Planning Commission
July 20, 2021 – 6:00 p.m.
233 South Main Street, Monroe, Ohio

TO: Members of the Monroe Planning Commission
FROM: Kevin Chesar
Director of Development

DATE: July 20, 2021
RE: Information Packet for July 20, 2021 Planning Commission Meeting at 6:00 p.m.

I. Case No. 2021-1-1 (TABLED)—Consideration of a Site Plan for Thornton’s

MONROE THORNTONS		DRAFTING: PJT	DATE: 10/16/2020
OVERALL SITE PLAN		DESIGN: JPS	SCALE: 1" = 20'

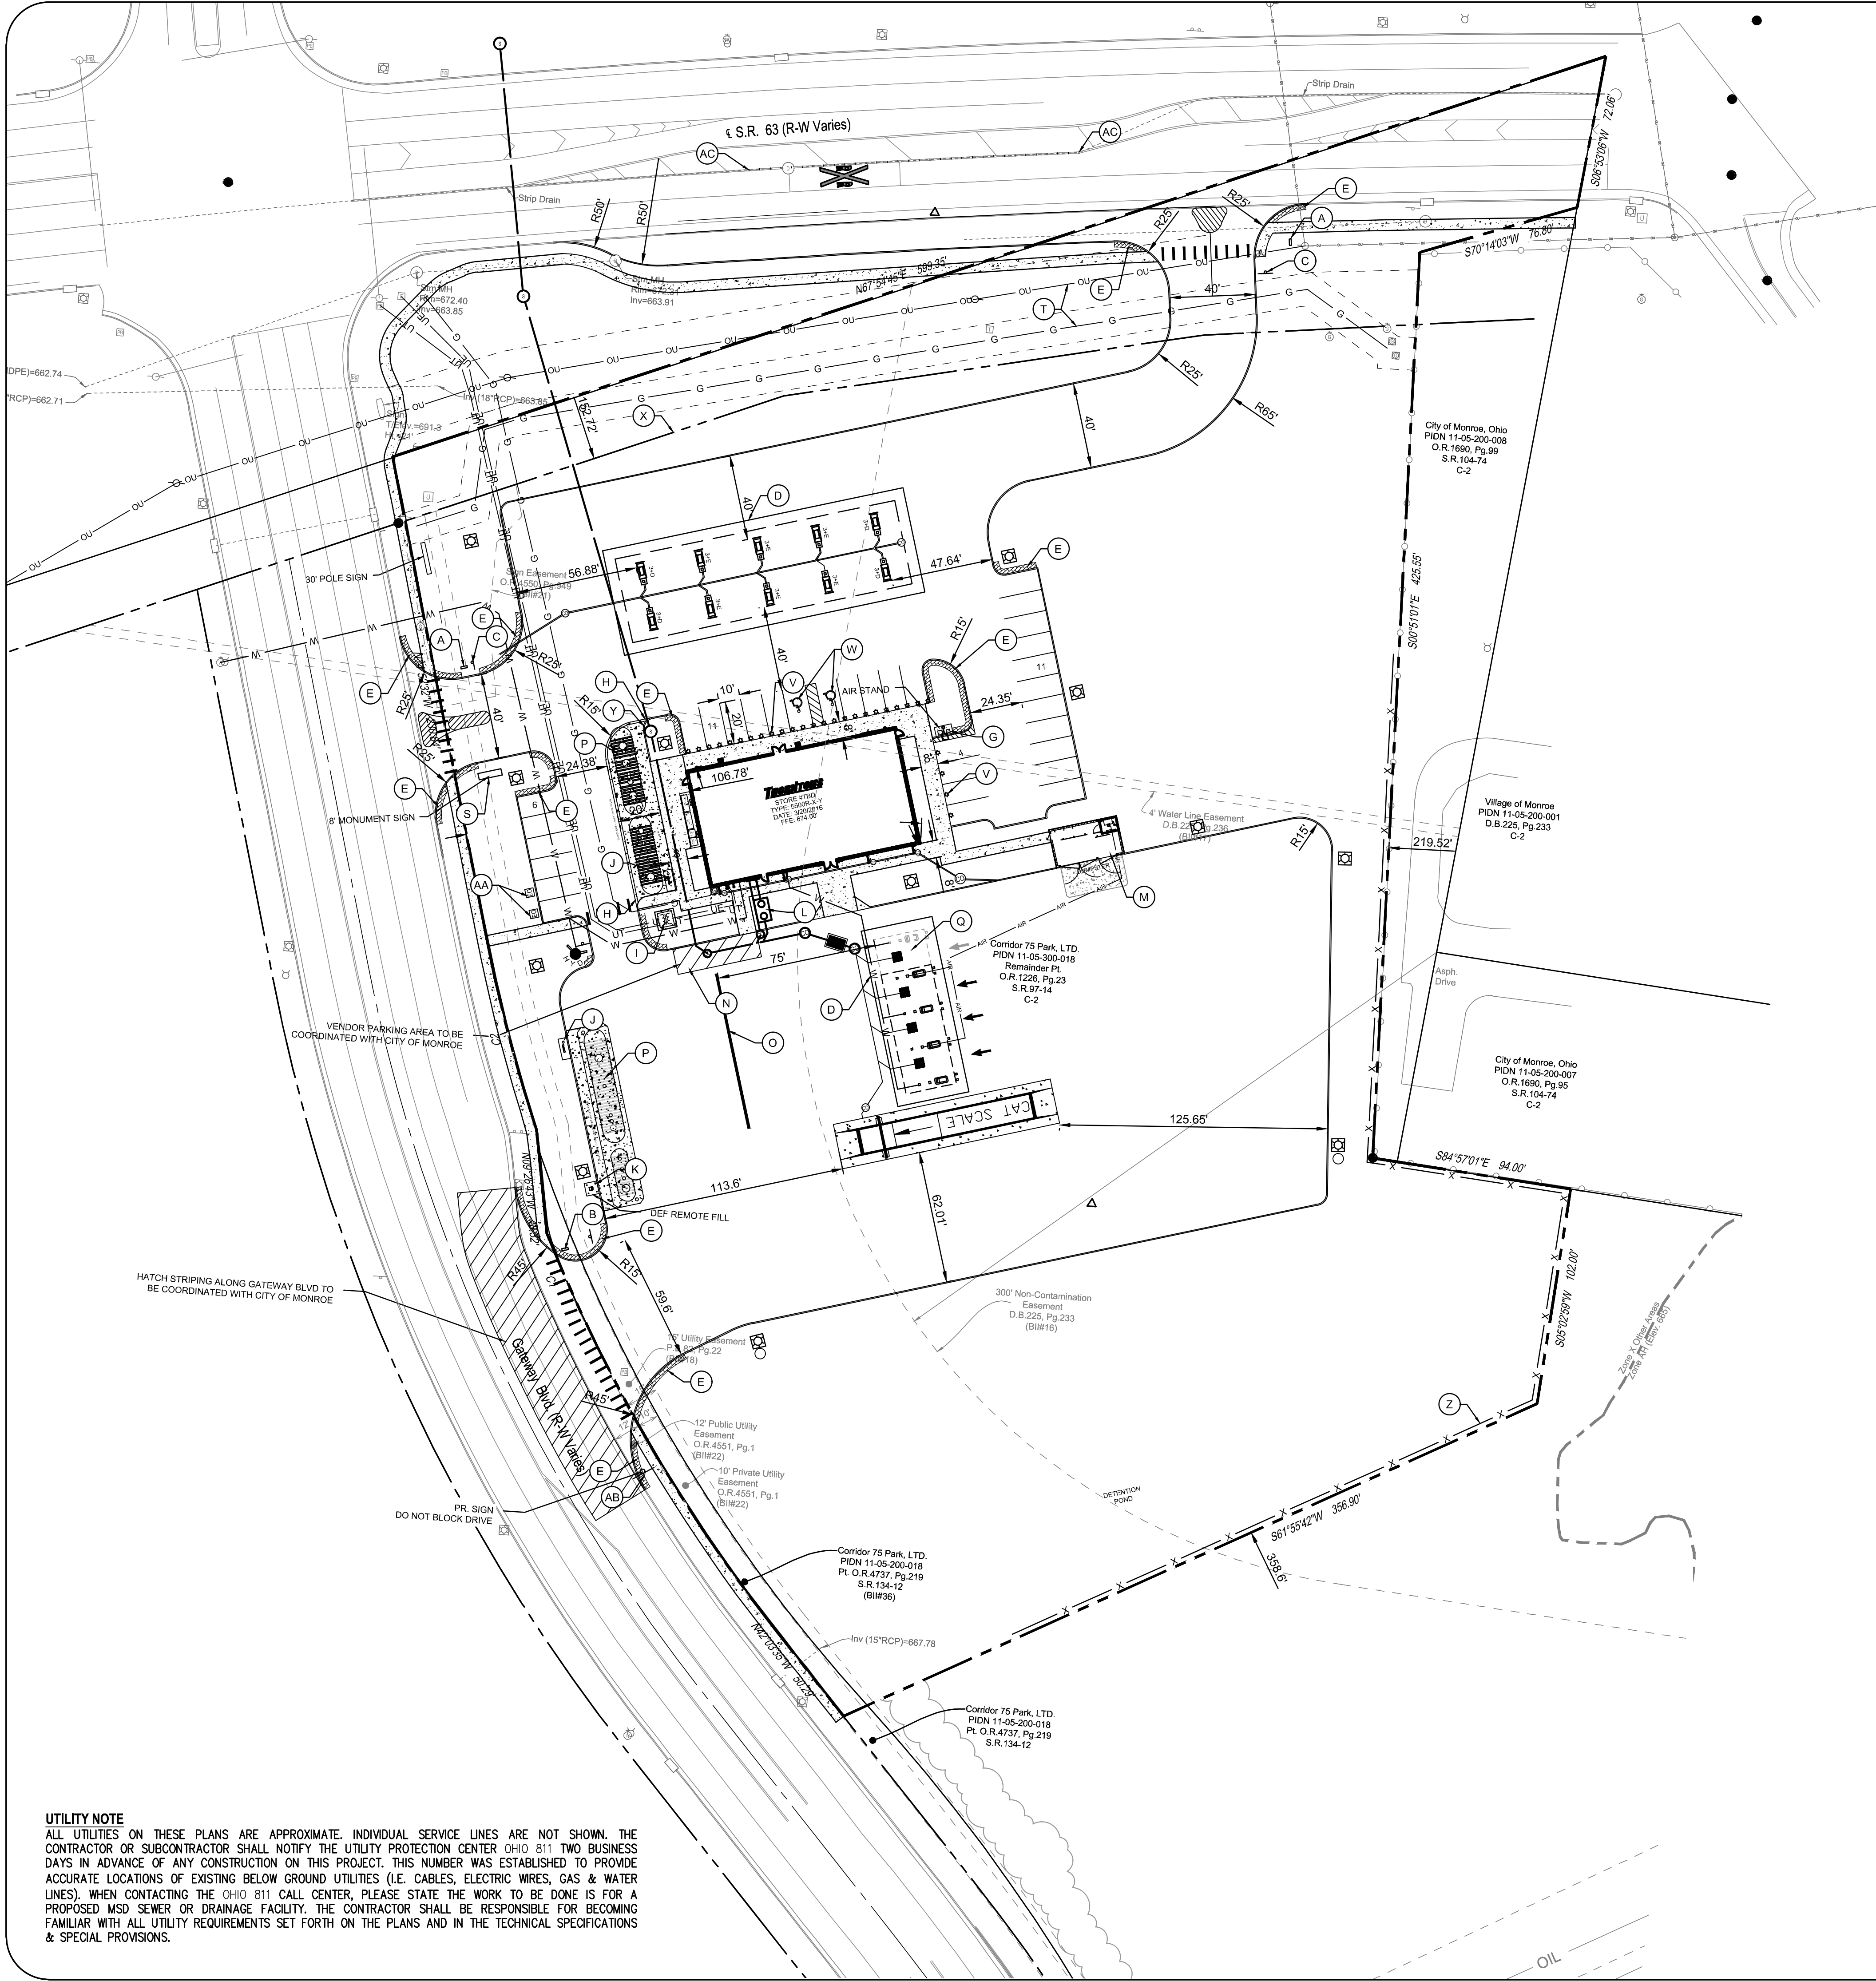
1. **Comment: Per revised civil plans submitted by applicant, semi parking stalls are shown as 'Future Truck Parking'. Stalls and Labeling must be eliminated from the site plan as part of the use requirements is not permitted. (1204.04(D)(15) and (1204.04 (D)(4) Response: Semi-Truck parking stalls have been removed from the civil plans**

The plans now appear to show the vehicular use area outside of the right-of-way, however, plans need to mark the specific distance from the right-of-way line to the edge of pavement to ensure compliance with the minimum 6-foot setback for vehicular use areas.

The applicant still shows a small portion of the right-of-way at the northeast corner of the site for landscaping purposes, but has not filed an Alternative Equivalent Compliance permit.
3. **Comment: Vehicular use area are shown within the right of way and will need to be set back to a minimum of 6 feet wide area from the right of way intended for landscaping. (1211.03(C) Response: The applicant intends to file for a waiver of this requirement along State Route 63**
 - a. A Right-of-Way permit will need to be completed to locate in the right-of-way. As a note, staff is not aware of vehicular use areas as being permissible in the right of way.

As mentioned previously, plans now appear to show the vehicular use area outside of the right-of-way, however, plans need to mark the specific distance from the right-of-way line to the edge of pavement to ensure compliance with the minimum 6-foot setback for vehicular use areas.

4. **Comment: The fuel canopy is required to be 15 feet from the closest point of right of way. The requirement is not met and will need to be corrected, which may require other site plan adjustments. (1204.04(D) and (1204.04(D)(4) Response: The applicant intends to file for a waiver of this requirement along State Route 63**

The applicant has moved the fuel canopy further back from the right-of-way and now appears to be compliant with minimum setback requirements. However, the distance needs to be shown on the site plan from the furthest edge of the canopy to the ROW line.

5. **Comment: Right of way sidewalks (5' min width) are required along Gateway Blvd and State Route – 63. Staff is recommending installation of the sidewalks on both roadways. (1208.07) Response: The plans have been revised to reflect the sidewalk along State Route 63. The sidewalk along Gateway Blvd. remains as previously shown**

The sidewalk location appears to have been revised. Staff would need to confirm the right-of-way standards for the 5-foot walk and 5-foot tree lawn are met.
6. **Comment: A solid screen of shrubs at a minimum installation height is required on the west side parking row (1212.07(B)**

14. **Comment: The spacing between the access driveways does not meet code.** *Response: The applicant intends to file for a waiver of this requirement. Entrance uses (trucks vs. cars) require separate locations to minimize interaction for safety*

- a. *Safety concerns for site do not warrant creating safety issues within the public right of way. The comment relates to spacing between access points and the response does not address this conflict.*

WEST ELEVATION

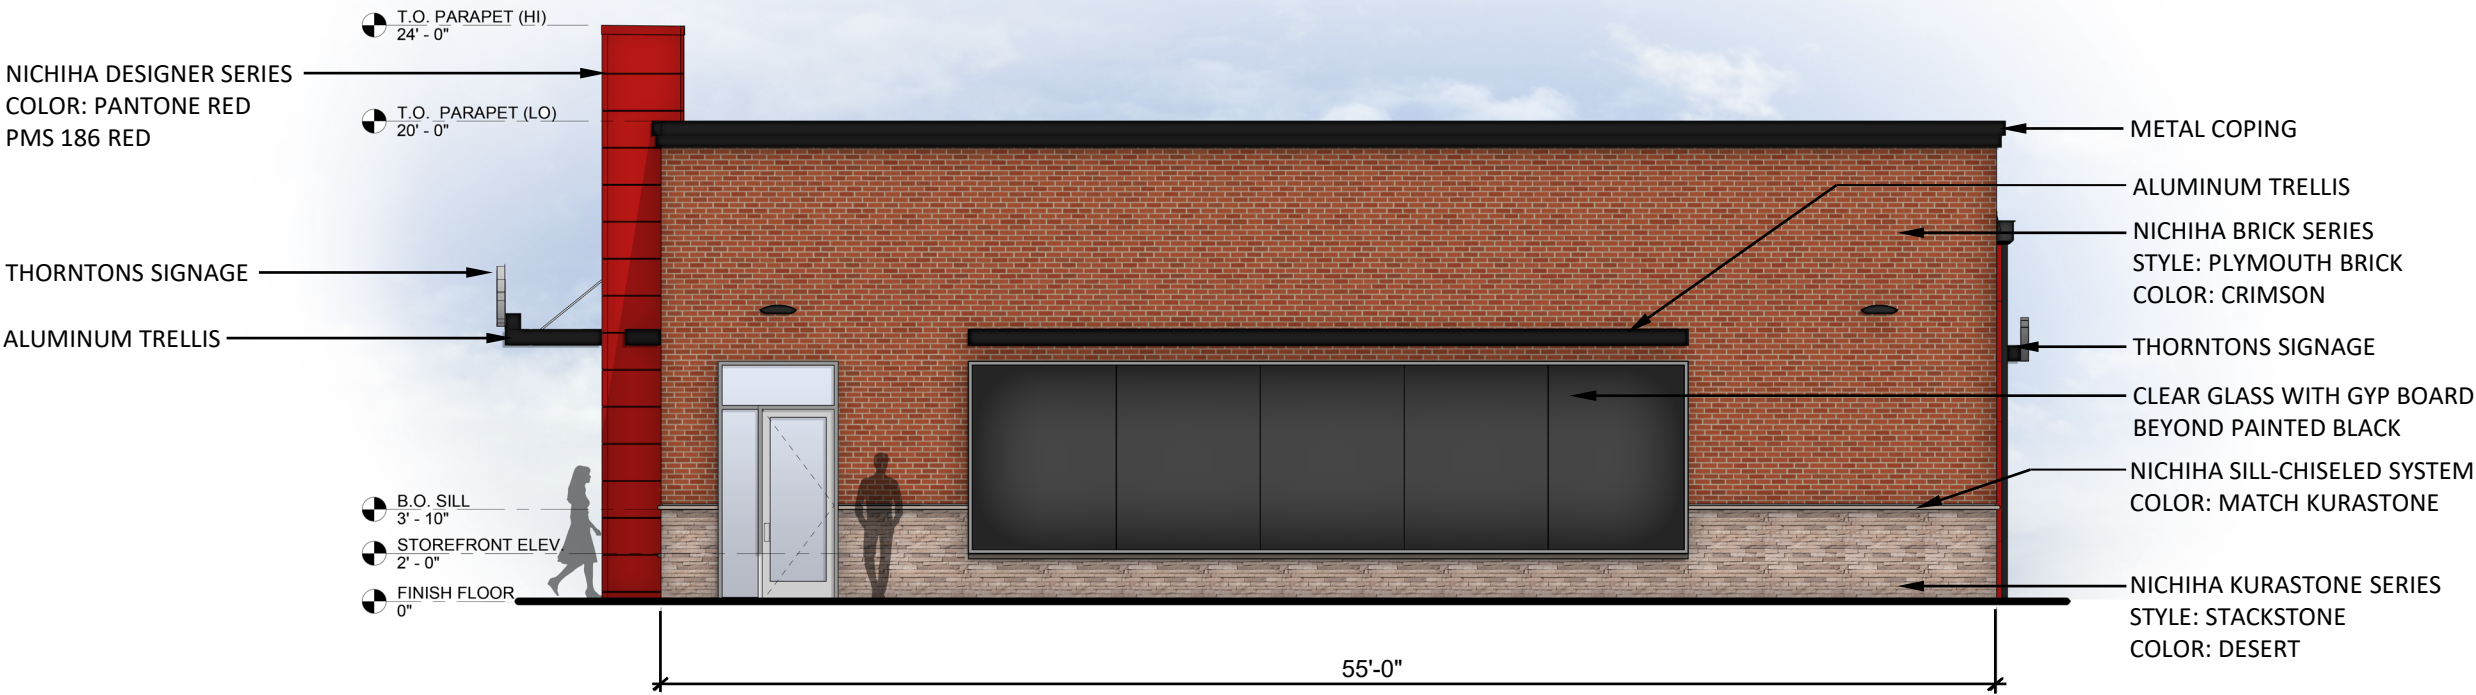
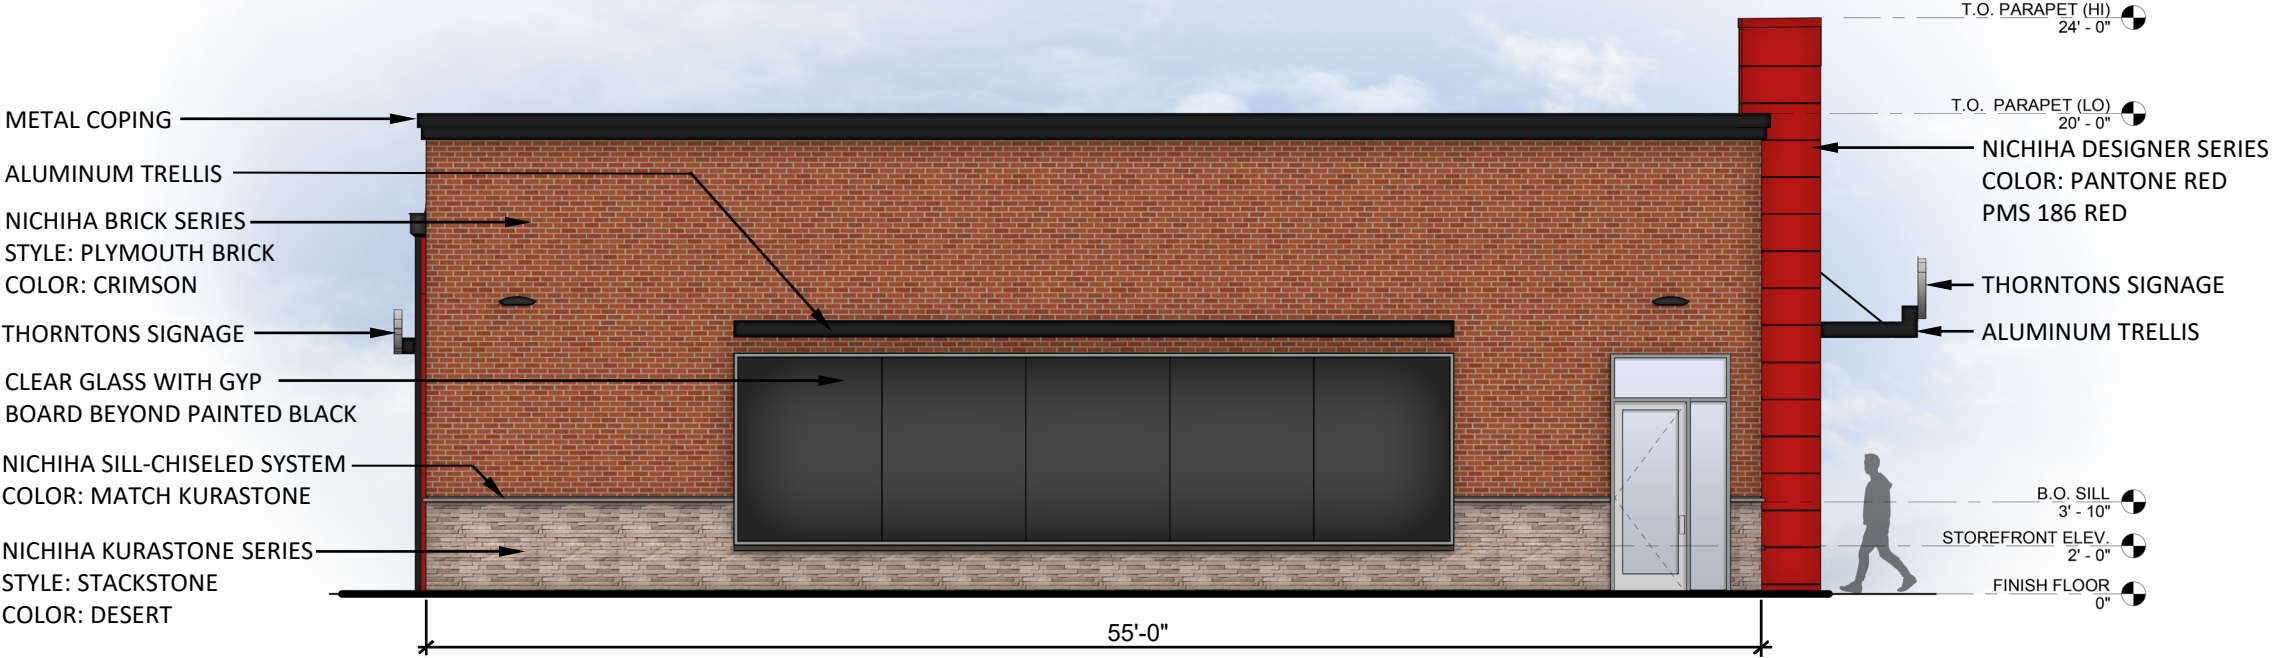
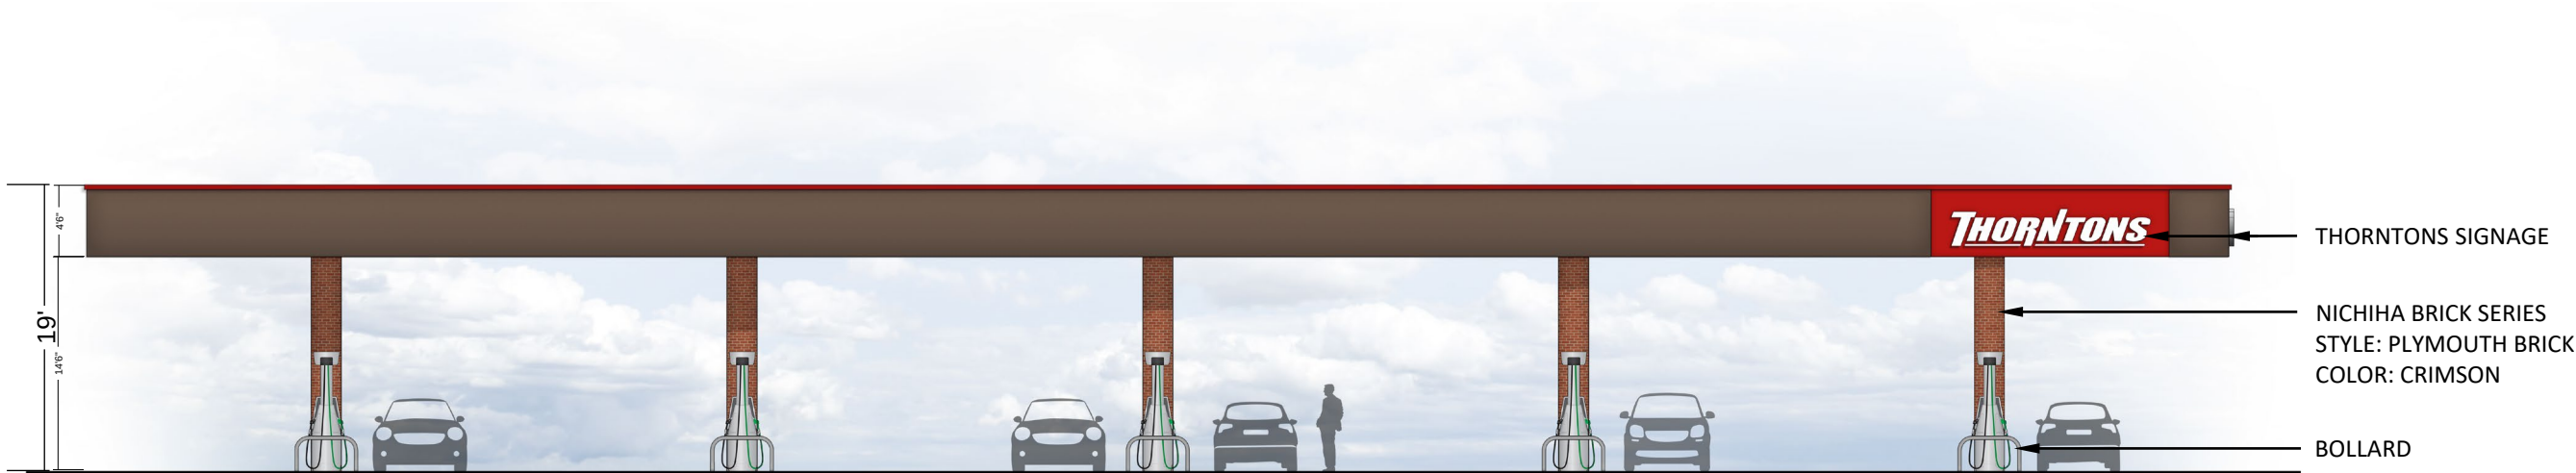
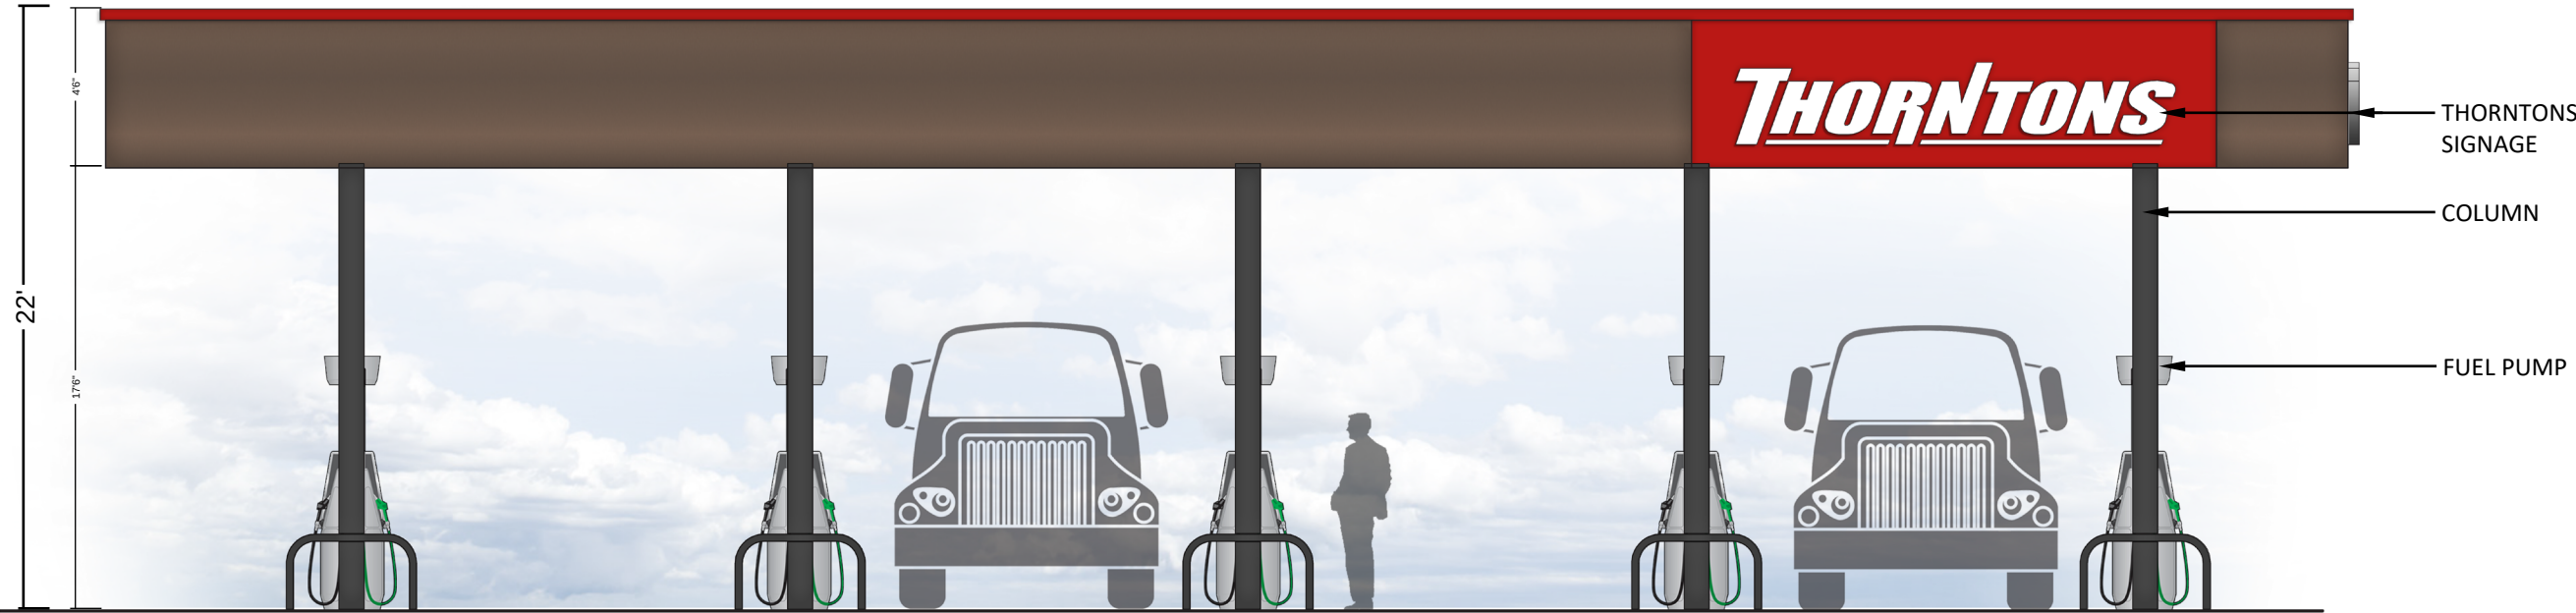
- a. *Applicant has indicated they will revise.*
Plans have been revised to show 4 truck refuel pumps across plans.
- 22. Comment: 25% of wall area visible from a right-of-way/public road must contain windows. As the site has visibility from multiple points on Gateway Blvd and State Route 63, this window requirement applies to the south, east, and west sides in addition to the north side. The south side of the building does not meet this code requirement with almost no glass/window area proposed. Please revise (1210.05(D)(5). Response: Acknowledged. Additional glazing added to south façade. The applicant can request a 1203.10 Alternative Equivalent Compliance permit regarding Architectural Standards (for attached) to allow reduced glazing percentage on south façade due to interior plan (coolers and back of house) and architectural elements (entry staple and downspouts).**

- a. *Acknowledged.*
While additional glazing has been added to the south elevation, an Alternative Equivalent Compliance application has not been filed.

- 23. Comment: All walls visible from a public street that are at least 60 feet wide must incorporate offsets of at least 2 feet deep and 20 feet wide at a minimum of every 40 feet. This requirement applies to both the north and south sides of the building (1210.05(D)(4). Please revise to meet this code requirement or provide one of the following alternatives:**

- i. *Revised plans appear to meet this requirement on the south side.*
- 24. Comment: Base-body-cap percentages need to be indicated to show minimum 8% base and 8% cap across the entire building. While it appears the 8% base requirement is met on the majority of the building, it is not met on the north elevation and will require revision. Further, the cap proposed may**

not meet the 8% minimum required. Please provide accurate percentages that account for the black metal coping, which is the overall cap area and does not include the red and black metal entrance feature as it does span across all or a majority of the building, to ensure these requirements are met (1210.05(D)(1)). Response: Acknowledged. Base and cap revised to meet 8% requirement throughout.

a. While percentages appear to be met on all sides, it appears the calculations are still inaccurate. The applicant has indicated that they will revise to show calculations.

Plans have been revised to show accurate percentages that do meet code minimum requirements.
